From: [S Mason](#)
To: [Rebecca Noecker](#)
Cc: [Spencer Miller-Johnson](#); [*CI-StPaul Contact-Council](#)
Subject: Public Comment in Opposition to Proposed EGAOD changes. Add a rear setback and step back to the EGAOD.
Date: Friday, July 19, 2024 1:06:09 PM
Attachments: [1- ANNOTATED Parritz public comment presentation.pdf](#)
[2-ANNOTATED Parritz public comment presentation.pdf](#)
[3-ANNOTATED Parritz public comment presentation.pdf](#)
[4-comments.pdf](#)
[5-Comments.pdf](#)

ANNOTATIONS TO PUBLIC COMMENT IMAGES

Here is an image of 695 Grand flipped, with December Shadows.

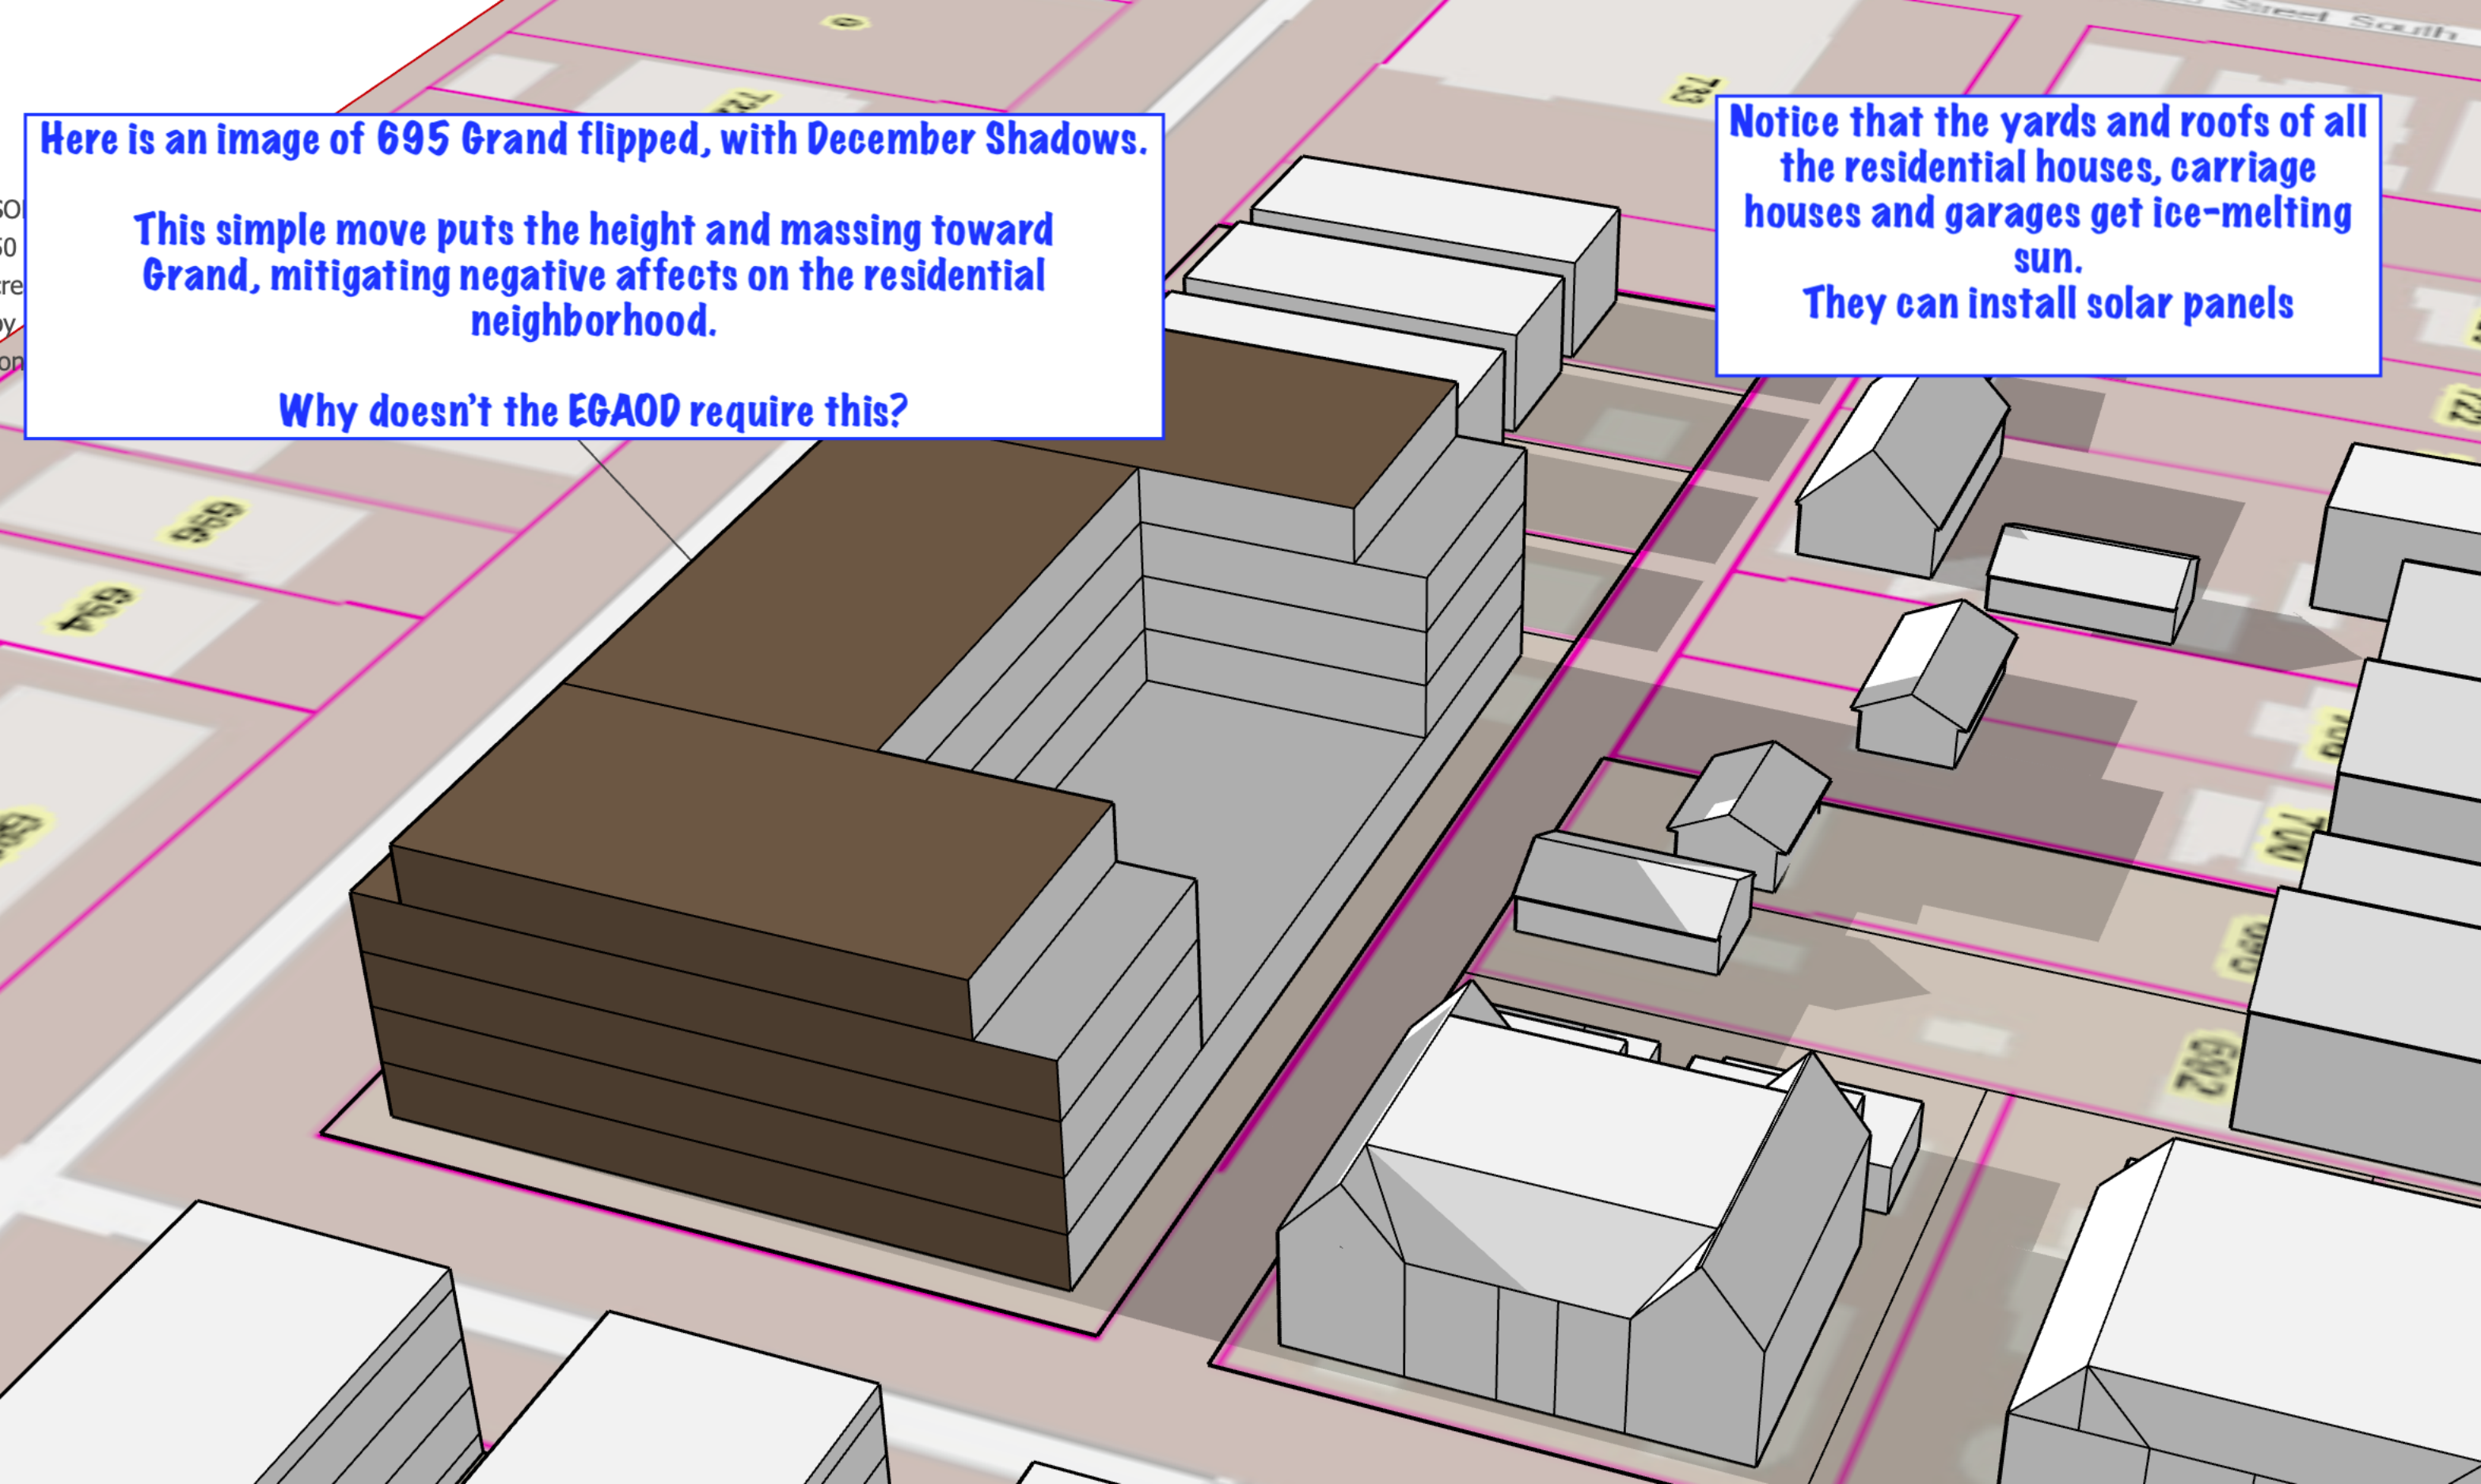
This simple move puts the height and massing toward Grand, mitigating negative affects on the residential neighborhood.

Why doesn't the EGAOD require this?

Notice that the yards and roofs of all the residential houses, carriage houses and garages get ice-melting sun.
